NASA/TM-2015-218809
NESC-RP-15-01039

Glenn Extreme Environments Rig (GEER) Independent Review

<p align="center">NASA Engineering and Safety Center Technical Assessment Report</p>	<p align="center">Document #: NESC-RP- 15-01039</p>	<p align="center">Version: 1.0</p>
<p>Title: GEER Independent Review</p>		<p>Page #: 1 of 22</p>

Figure 7.1-1. Pressure System Component Tags

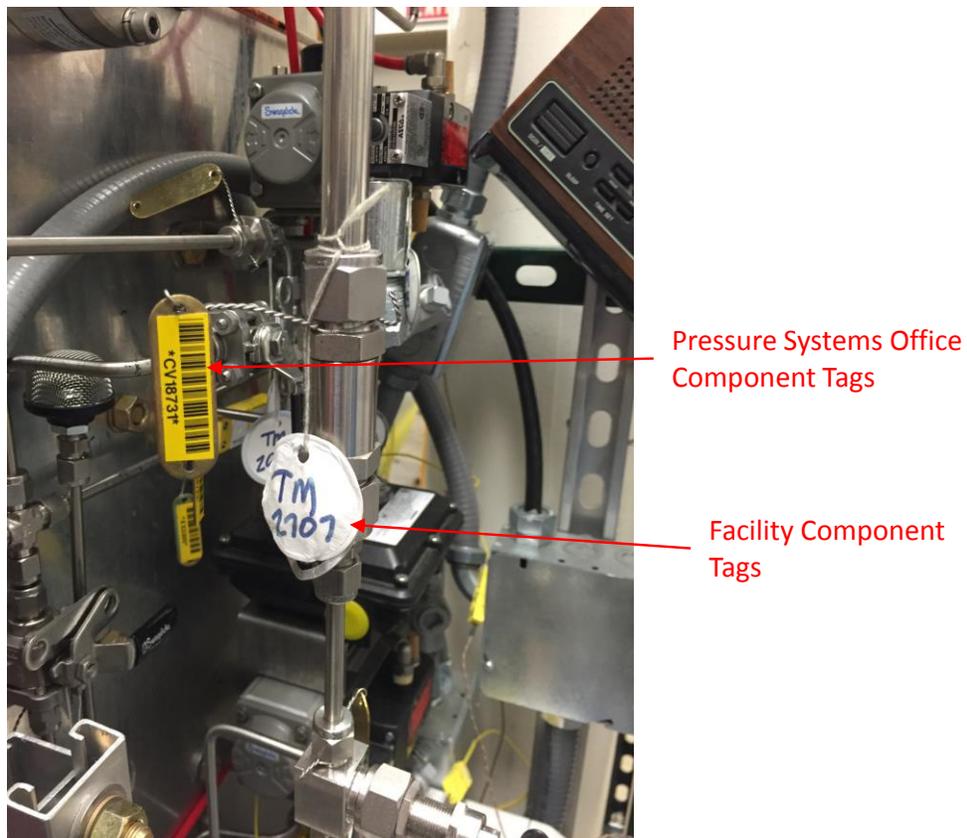
- F-8.** The relief valve (TM2703/RV6094) from the booster vessel was not installed in accordance with the P&ID.
- F-9.** Facility engineering's component tags were not secured permanently and were not found in some locations on the rig (Figure 7.1-1).

- F-10.** Two configuration management systems (PSO and facility engineering) are being used for pressure system components (Figure 7.1-1).

- R-5.** Update all documentation to be consistent with present design and operating procedures and review the changes with all qualified operators before the rig is operated each time. *(F-5, F-7, F-8)*
